NRC-011-R

Combined License Application Review Levy Nuclear Plant Units 1 and 2

Safety Panel July 28, 2016

Key Topic - Voids Created by Dissolution of Limestone in the Foundation Rock Unit

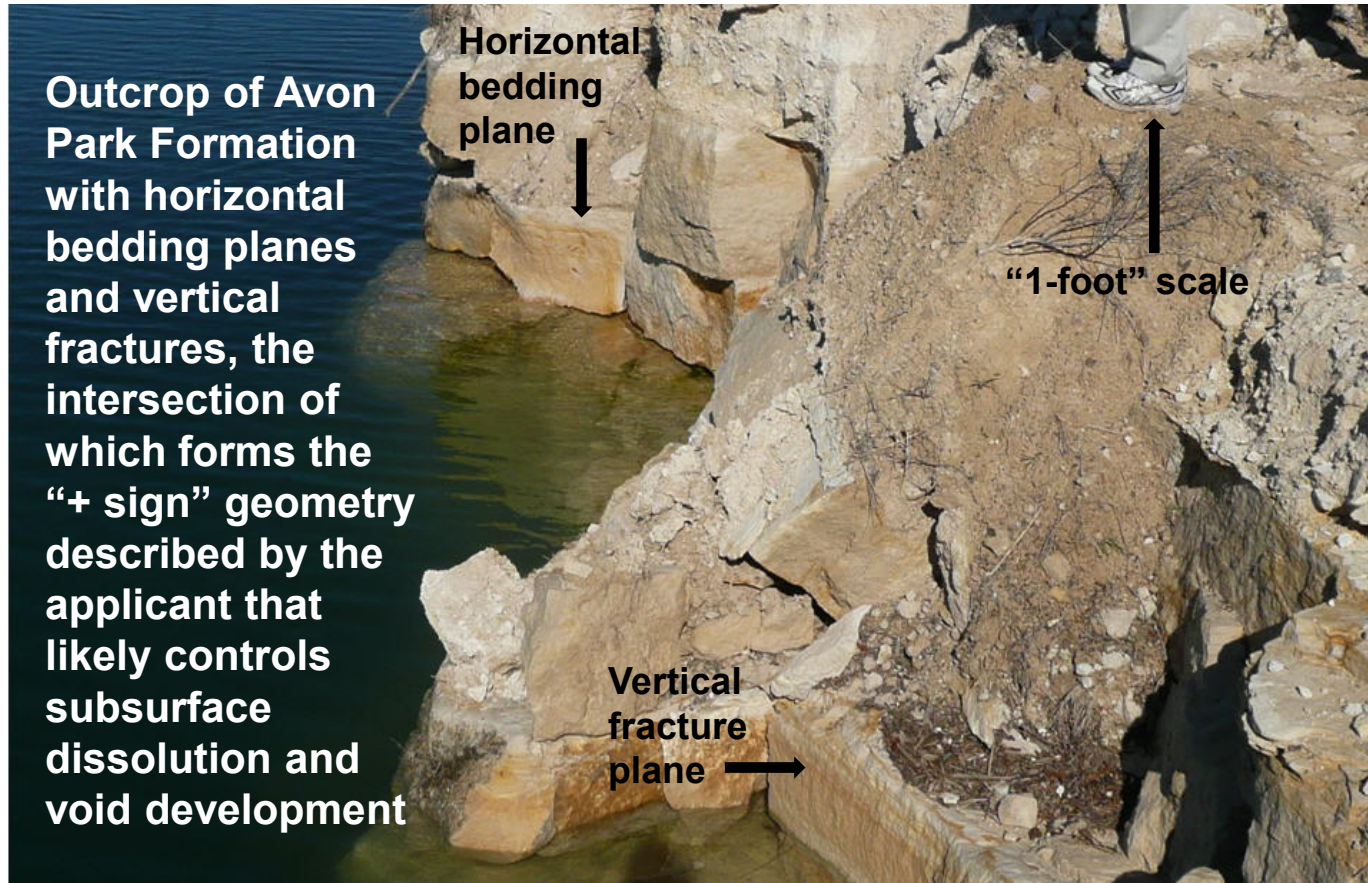
- **Applicant identified potential for subsurface voids created by dissolution of limestone in the foundation unit (Avon Park Formation, >40 million years old) as the primary geologic hazard at the site.**

Staff Conclusions

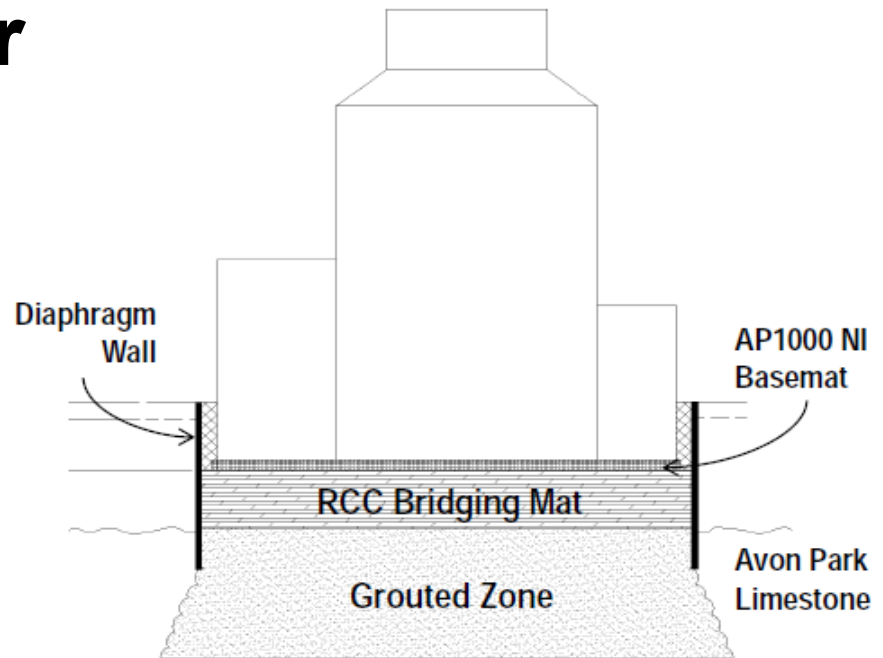
- **Field data support postulated maximum dimensions of dissolution voids in the Avon Park, and the interpretation that majority of voids are not more than 1ft in diameter.**
- **Subsurface voids will not detrimentally affect stability or suitability of the Avon Park.**
